BRONZE STORM VALVE

BUREAU VERITAS Section02214J

BUREAU VERITAS	Technical Comments Letter		30 Oct 2012
	Marine Division		O. Mail Ref. : DT2/12/03349
	BV Reg. No : 02214J Project : HMAS SUCCESS		Hull No :
	Yard(s) :

Drawing number **Z63G Rev 0**
BRONZE STORM VALVE

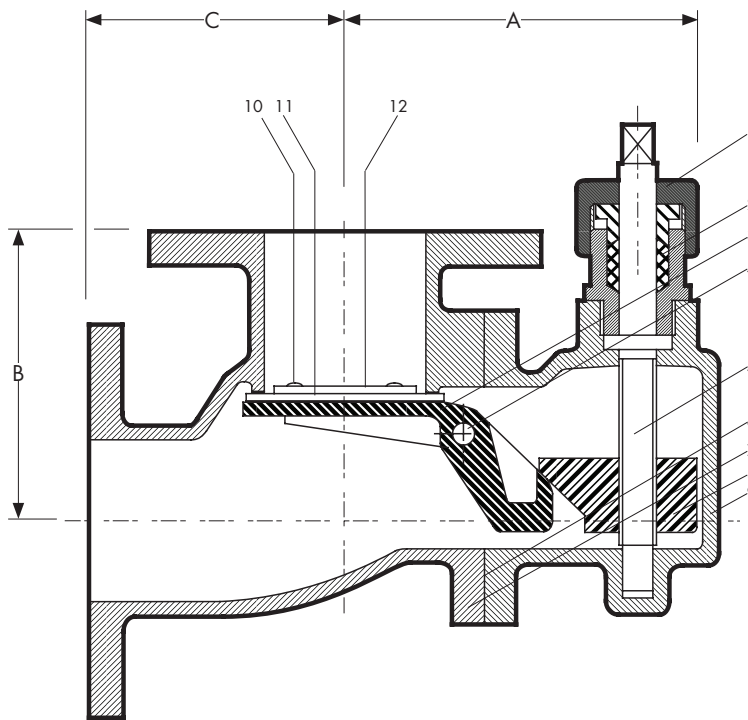
| <i>To be dealt with</i> | Inspection and testing at works for the valves are to be carried out in accordance with BV Rules, Pt C, Ch 1, Sec 10-Table 38. |
| <i>To be dealt with</i> | Since the intention is to fit the valve on the shell plate, then the valves should be provided with positive means of closing, i.e. with geared hand wheel. |
| <i>To be dealt with</i> | Valves fitted on the ship side are to be provided with indicator showing whether it is open or closed. |
| <i>To be dealt with</i> | Valves and distance pieces intended to be fitted on the ship side below the load waterline are to be subjected to hydrostatic tests under a pressure not less than 0.5 MPa. (Pt C, Ch 1, Sec 10-20.4.3.b)

The test pressure on the drawing is to be amended accordingly. |

| <i>To be dealt with</i> | Since the material of the valves is bronze, please note on the drawing that the valves are not allowed to be used as boiler blow-down valves connected to the shell plating. (Pt C, Ch 1, Sec 10-Table 5) |
